Memorandum

RE: May 2, 2017 Working Group Meeting Follow Up
SW Area Road & Traffic Working Group
S&A Project No.: 116.0848.01

Option C (red alignment) – Hydraulic/Drainage Issues

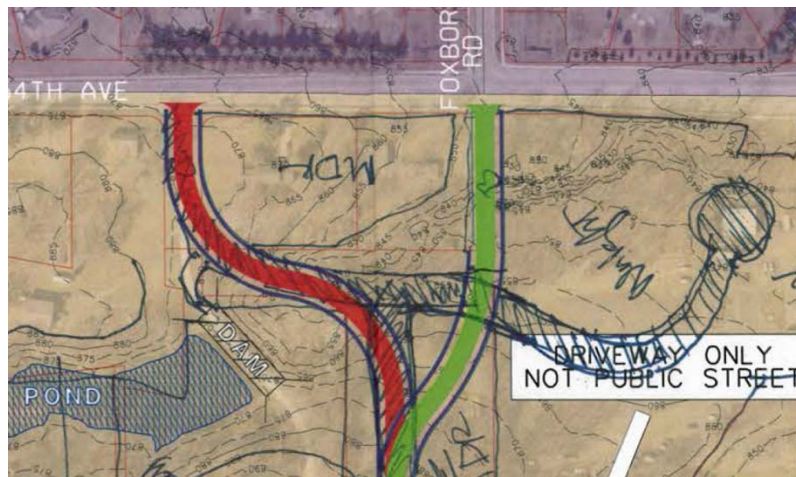
Although the red alignment provides an alternative to Option B (green line) for an offset to the Foxboro Rd direct alignment/extension concerns, it does present several challenges in constructability with the current private pond and downstream channel.

1. Per review of historic aerials, pond seems to date back in to late 60's or early 70's at least.
2. Could it have been built with any sort of federal aid, soil conservation funding grants?

3. Doesn't appear to be a detention facility.
4. Appears to lack a spillway, just a pipe which releases water once it reaches that elevation upstream of dam.

5. Appears size would require permitting by today's standards (Iowa DNR).
6. Uncertainty as to original construction and material/soil make up of current dam.

7. Building the road per exhibit alignment would place earthwork "burden" on existing dam. Would need to understand soils, geotechnical engineering to determine if feasible.

8. Stream channel and wetland mitigation potential, environmental review / 404 permitting.
9. Best choice for Option C would be to take the place of the existing dam. However, construct in an alignment slightly further downstream, perhaps "flatten" the curves a little from the exhibit alignment. Some additional items:

- a. Assumes Woodsmall property would have interest and willingness
 - b. Impacts on multiple property owners in upstream area (4-6 minimum)
 - c. Reanalyze the drainage area and hydraulics (possible 0.25 SQ mile area - see attached map)

- d. Greater potential ROW acquisition for City, if City does not purchase still drainage easement issues

- e. Update standards of the dam, potential permitting
- f. Likely ownership by City with public street
- g. This would require extensive geotechnical work, more extensive engineering for roadway
- h. Likely a situation of draining current pond, start over with construction of dam to guarantee design and construction materials
- i. Long term maintenance for City
- j. Significant cost increase for the similar portions of Option C or Option B from the point at the “Y split”. Per prior cost opinions for roadway, could result in \$400k to \$750k cost increase (see attached spreadsheet)
